HORSHAM DISTRICT COUNCIL CONSULTATION

TO:	Horsham District Council – Planning Dept
LOCATION:	Land North West of Southwater
DESCRIPTION:	Outline planning application, with all matters reserved (except for primary access to the highway) for a phased development comprising: the demolition of existing buildings and the construction of residential dwellings (including affordable housing) (Use Classes C2 and C3); a mixed-use neighbourhood centre (Use Classes E and F); education facilities (Use Class F1(a)); business and employment floorspace (Use Classes B2, B8 and E(g)); redevelopment of existing agricultural buildings including construction of a building for community use (Use Classes E and F2); improvements to public rights of way; sports pitches; gypsy and traveller pitches/plots; public open space; landscaping, and associated infrastructure.
REFERENCE:	DC/26/0366
RECOMMENDATION:	No Objection / More Information / Modification
SUMMARY OF COMMENTS & RECOMMENDATION: Please note the request for a number of minor amendments to the parameter plans, together with the provision of additional supporting information. In addition, please be advised that the LVIA remains under review at this ti

Contextual wider panoramic extent of the view

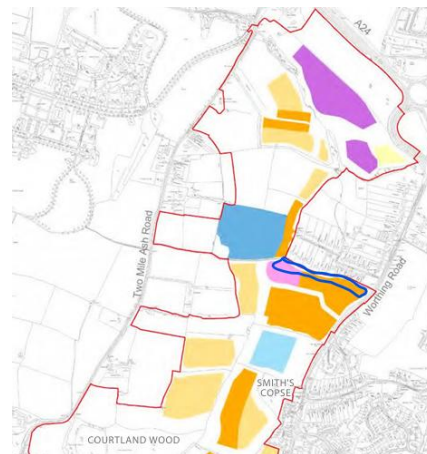
The LVIA identifies the effects of the proposed development on users of prowl 1662 (VP 06) as major adverse at year 1, reducing to a residual moderate adverse effect over time. An extract of VP06 is copied below.

Site observations and the accompanying V06 photograph indicate that existing vegetation along the section of the prow adjacent to this most western field is limited and kept at a lower height along Two Mile Ash road. The retention of the current boundary treatment is desirable, as the field remains intrinsically reflective and connected to the existing field pattern, and no development is proposed at this stage within this field, nevertheless careful consideration must be given to strike the right balance between retention of existing character and softening/ filtering of views. With this in mind, a future reserved matters application should adopt a light touch approach to the field's boundary, mostly limited to gapping up where required with the understating that this approach may need to be reviewed, should future proposals for school expansion come forward.

Parameter Plans – **Landscape and Open Space**

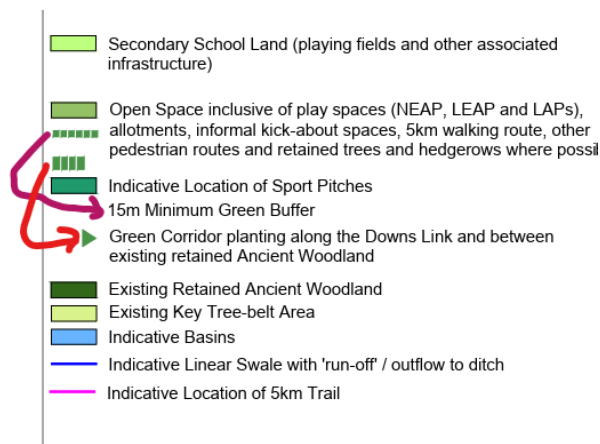
7. Please indicate existing hedgerows within the developable areas as existing retained important hedgerows. **Not addressed.** While having these indicated within the controlling document is a more robust approach, the hedgerows to be retained are indicated within the AIA appendix 2 'Tree removals Plan' therefore we are satisfied that any inconsistencies can be referred back to these documents. **Closed**
8. Differentiate sports pitches from developable area within secondary school site, particularly the field to the west which is earmarked for future expansion for sports provision only. **Closed**

As an aside on this parameter plan, please note the key is out of sink and that the dashed lines for the 15m buffer and green corridor are as per the mark up.
